Subject: MHI's 2nd Amended Response to US-APWR DCD RAI No. 740-5719 Revision 2 (SRP 06.02.02)

2nd Amended Response to Request for Additional Information
No. 740-5719 Revision 2

RAI NO.:	**NO. 740-5719 REVISION 2**
SRP SECTION:	**06.02.02 – Containment Heat Removal System**
APPLICATION SECTION:	**6.2**
DATE OF RAI ISSUE:	**4/26/2011**

QUESTION NO.: 06.02.02-64

Figure b-1 Film Condensation at Structure Surface

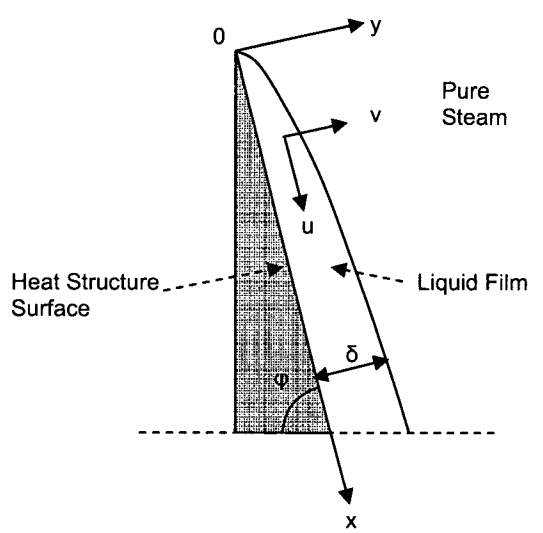
- o Condensate water on containment surfaces – Equation listed for film condensation correlation used to calculate film thickness could not be readily verified (reference in Japanese) and was not found in standard textbooks on heat and mass transfer. Appropriate reference and justification should be provided for the applied methodology and selected input values. Film thickness will be a function of the

surface height. Justify estimated vertical surface area and corresponding heights used in the calculations.

Condensate film thickness was calculated from Eq. 11 in the hold-up volume calculation based on the fluid conditions. The calculation follows the methodology of theoretically solving the Nusselt film heat transfer correlation, which is widely known (References 4 and 5).

Assume constant condensation and liquid flow on structure surfaces (Figure b-1).

Condensation liquid thickness on the surface of the heat structure is predicted by Eq. 11. The height used for this calculation was 40 meters (about 130 feet), and the resulting condensation film thickness (based on 40 meters height) was applied to all surfaces. The vertical portion of containment from the second floor level (EL 25'-3") is about 129 feet. If the vertical height (x) increases, the liquid film thickness also increases as shown in Eq. 11. However, the liquid thickness calculated based on a 40 meter height was conservatively applied to all surfaces.
